SERVICE BULLETIN

SERVICE BULLETIN				No.: MSB-97E26-002		
				Date: 1997-09-26	<model></model>	<m y=""></m>
Subject:	ADDITION OF FRONT AXLE SHAFT			E SHIM TO DRIVE	(EC,EXP)COLT (CJ0A)	96-10 96-10
Group:	FRONT AXLE DI		Dra	aftno: 97-TA-003	(EC,EXP)LANCER (CK0A)	93-10
INFORMATION		OVERSEAS SERVICE DEPT		R. Usami R. USAMI - MANAGER QUALITY INFORMATION ANALYSIS	(EC,EXP) LANCER WAGON(CB0W)

1. Description:

Front axle shim
9 11M0072

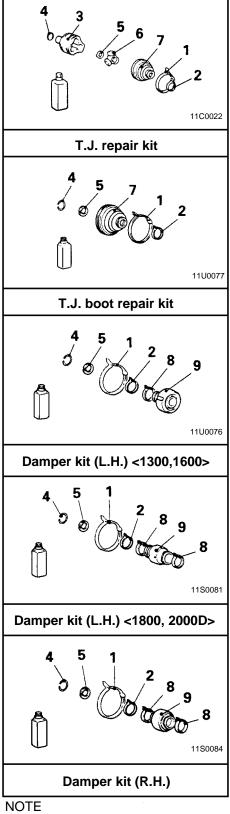
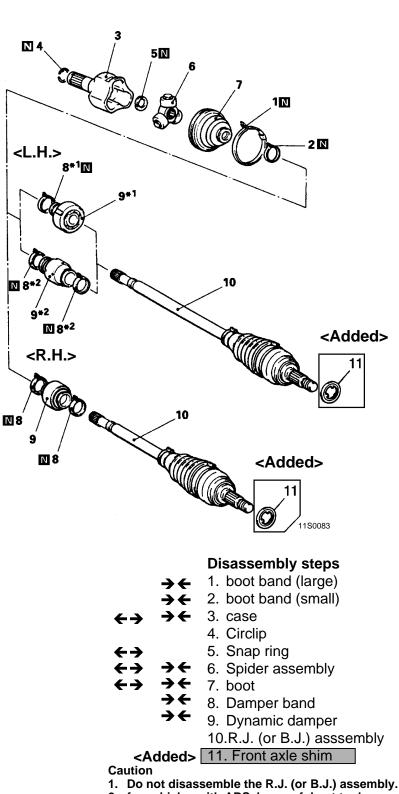
The front axle shim has been added to the axle hub end of the front drive shaft. This has bought about a change in the Disassembly steps.

E260E-2

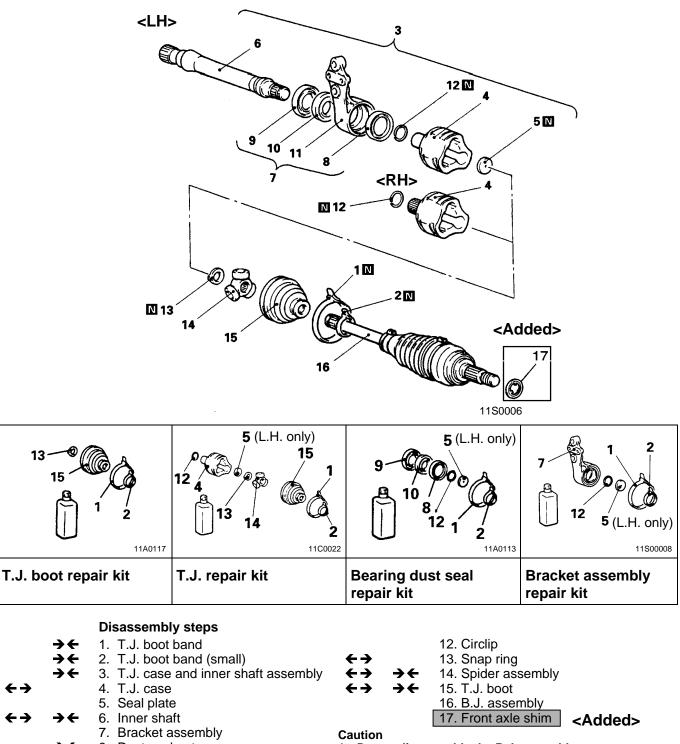
<Revised>
